# **RESPONSE TO SUBMISSIONS REPORT**

## **SSD6236: ENERGY FROM WASTE, EASTERN CREEK**

14 DECEMBER 2017  
SA5220  
FINAL  
PREPARED FOR THE NEXT GENERATION

Figure 3 – General site layout (source: Kriskis Taylor Architects; 2017)

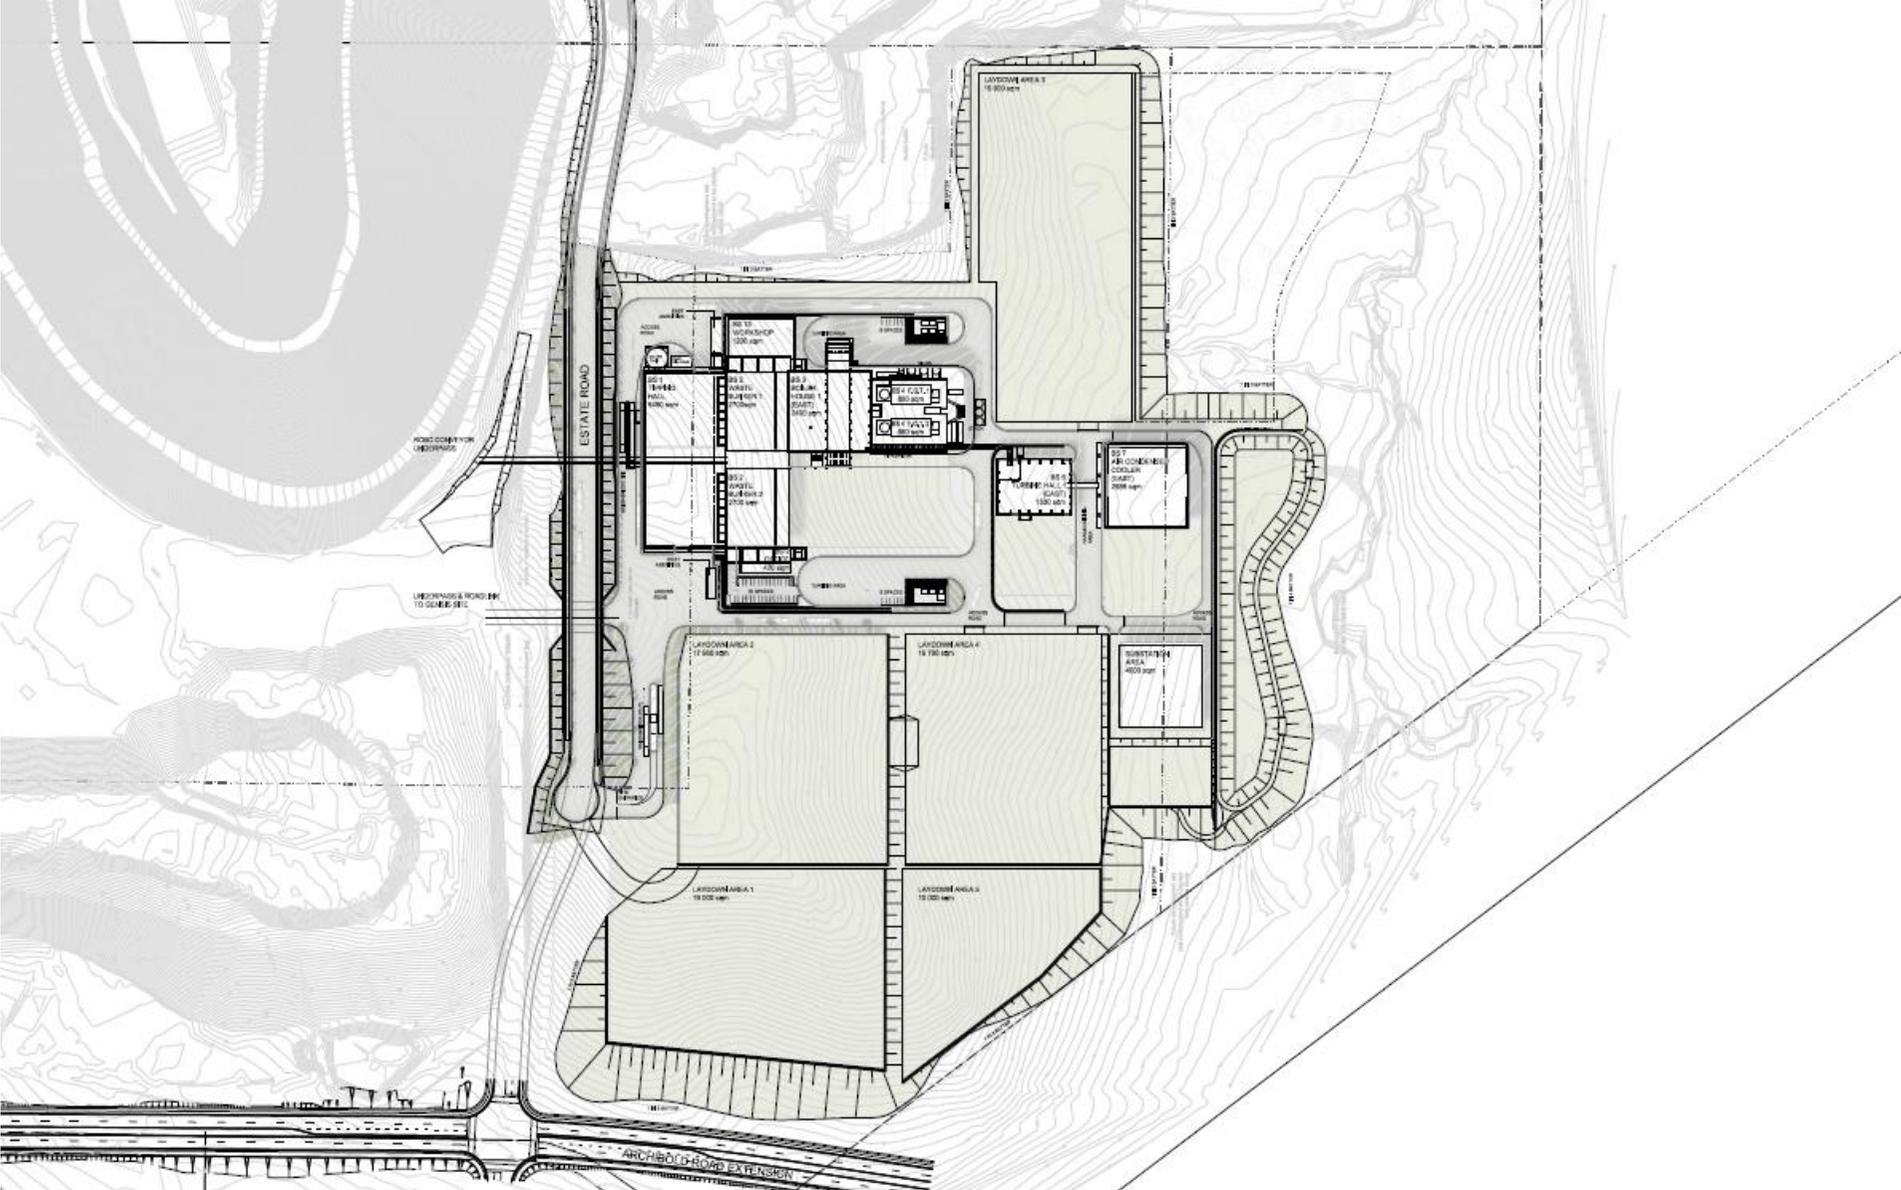
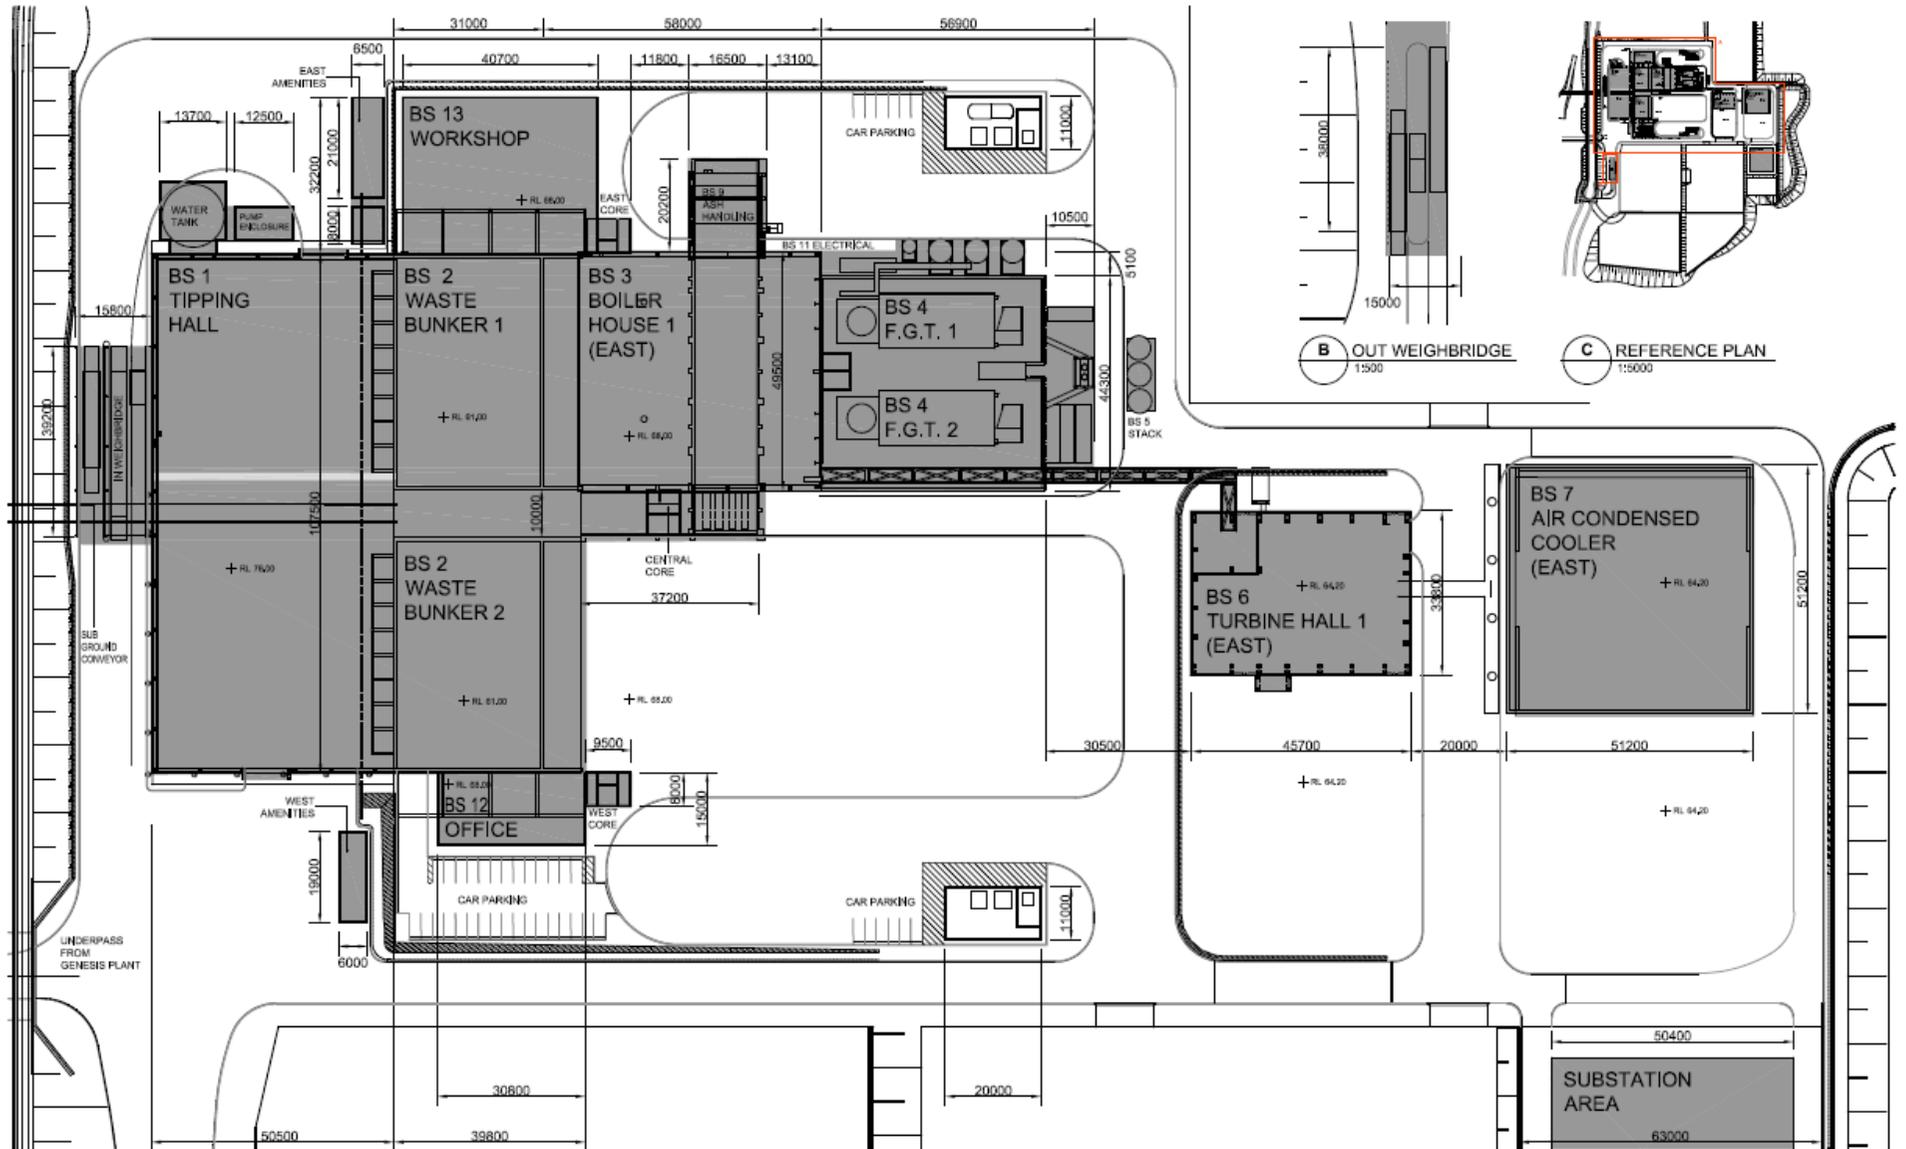
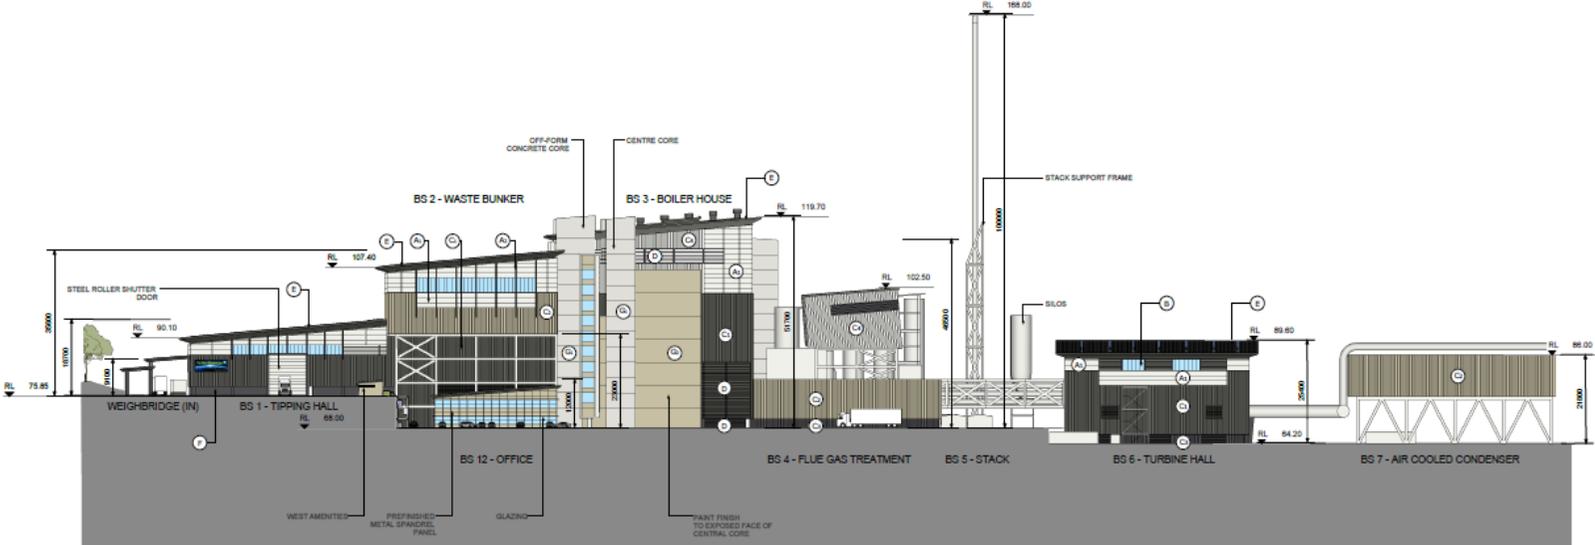
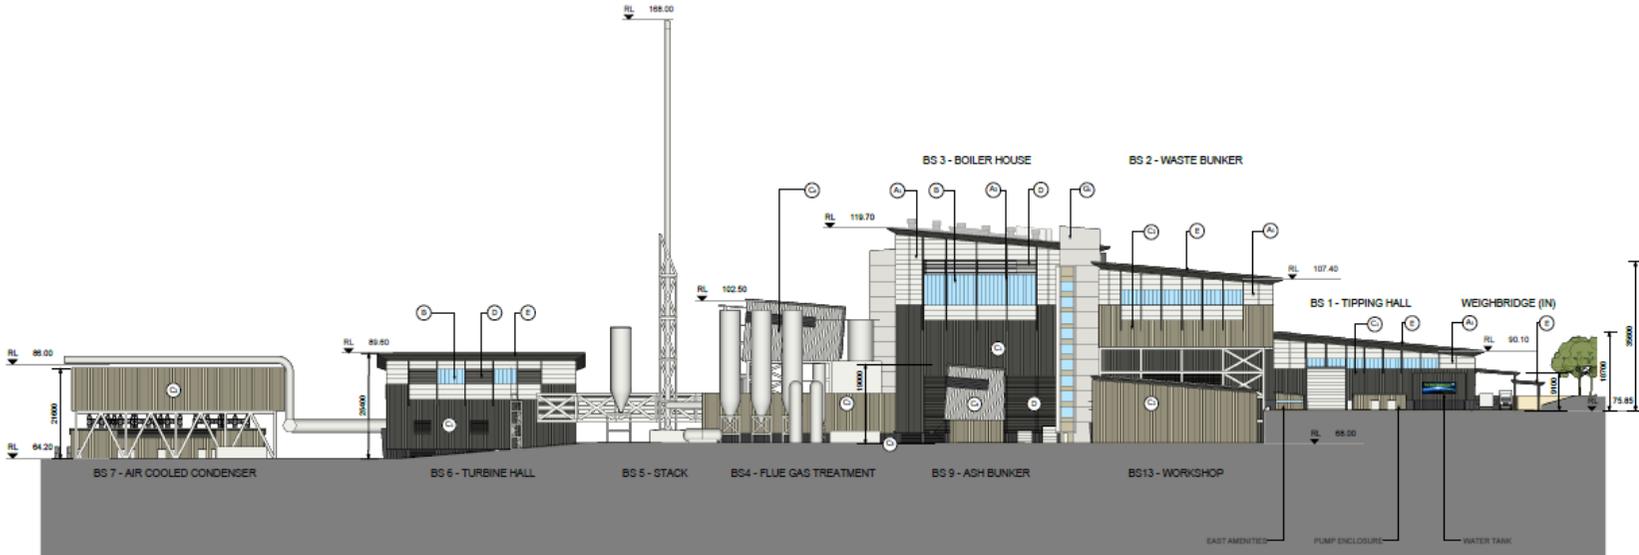
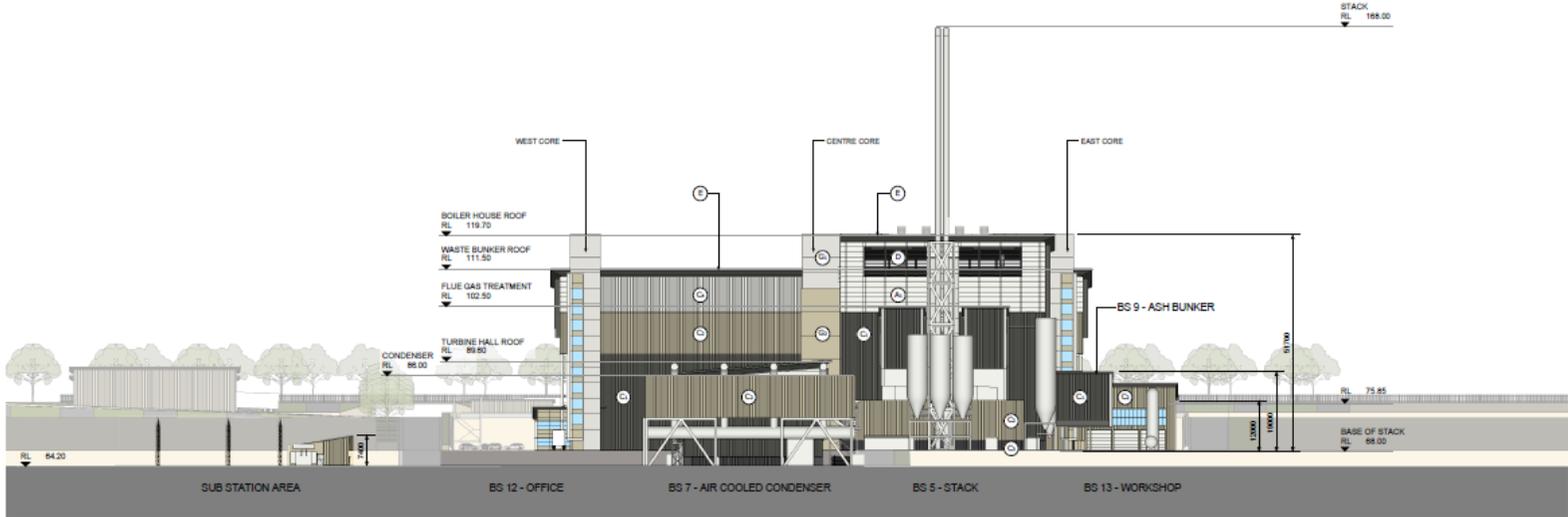
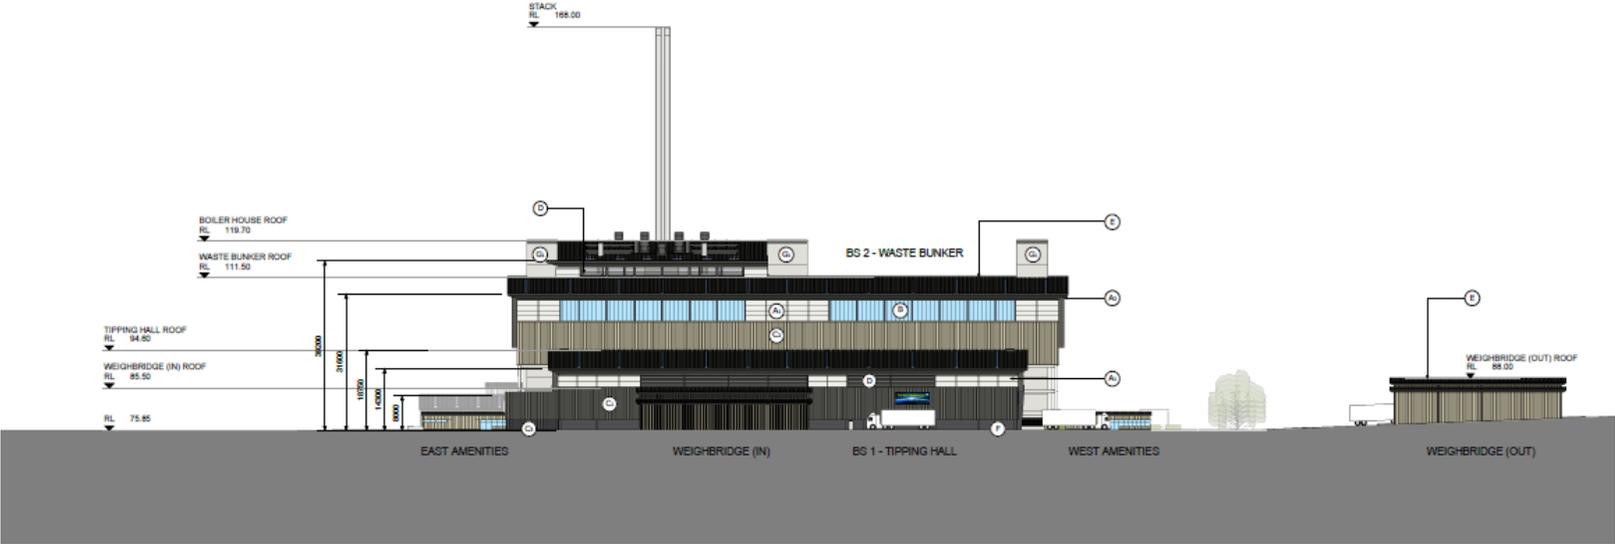
The SSDA is seeking development consent for the **construction and operation of Stage 1 only**, and for the treatment of 552,500 tonnes per annum of residual waste fuels (engineering capacity for approximately 405,000 to 675,500 tpa with an optimum expected throughput of 552,500 tpa). This will involve the following plant and systems as illustrated in **Figure 3-8** and the revised volume of plans at **Appendix E**:

Figure 9 – Proposed amendments to the Laydown Areas (Proposed General Arrangement Plan: AT&L)

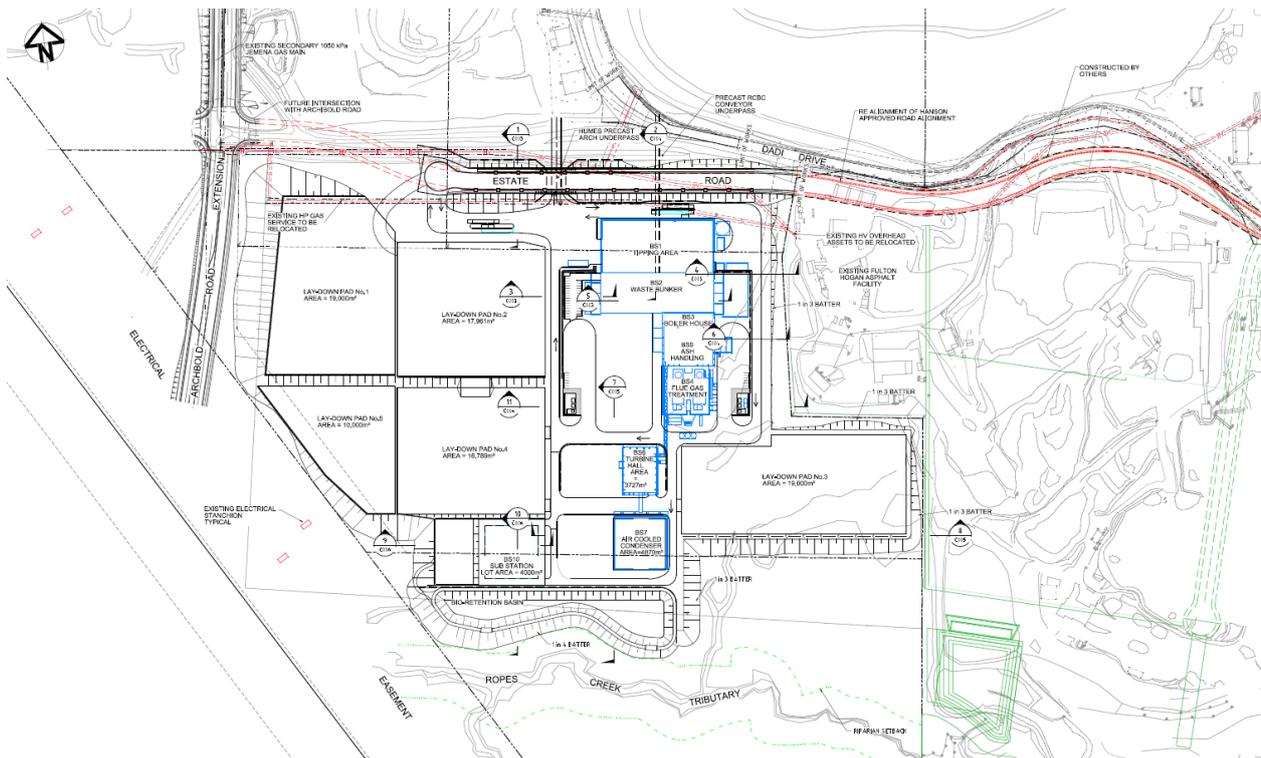
The proposed configuration of the pads has been redesigned to reduce the vegetation removal required for their construction and avoid biodiversity impacts as shown in **Figure 9** and as follows:

- Pad 1 – Area: 19,000sqm (new pad in unaffected area, no protected vegetation removal required)
- Pad 2 – Area: 17,961sqm (no change)
- Pad 3 – Area: 19,000sqm. A 23,764sqm reduction to pad size, southern extent reduced.
- Pad 4 – Area: 16,789sqm (no change)
- Pad 5 – Area: 10,000sqm (new pad in unaffected area, no protected vegetation removal required)

Figure 10 – Amended Plan of Subdivision

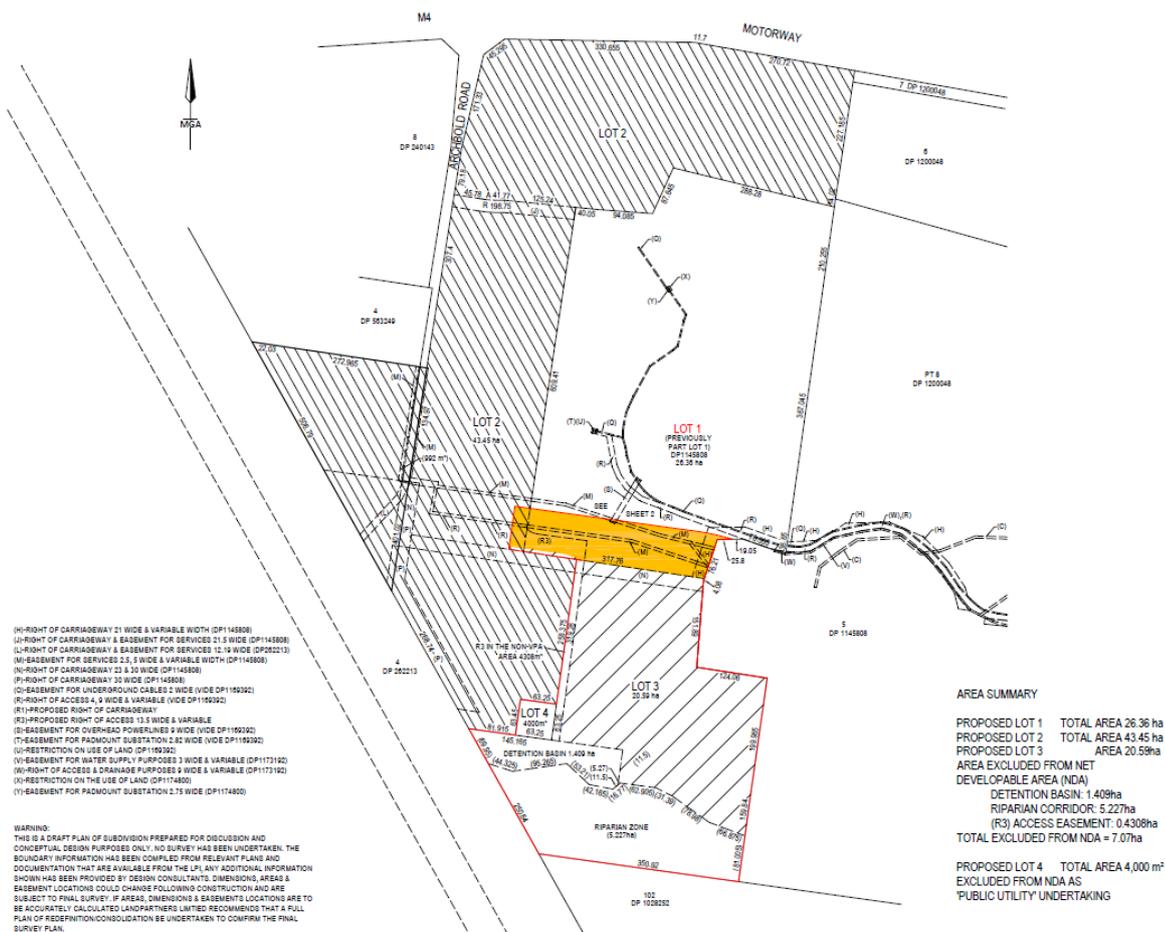
An amended subdivision plan has been developed to support the preparation, execution and registration of an appropriate Voluntary Planning Agreement for the purpose of guaranteeing the collection of contributions to ensure the delivery of infrastructure.

The amended subdivision plan is shown in **Figure 10** and attached at **Appendix I**.
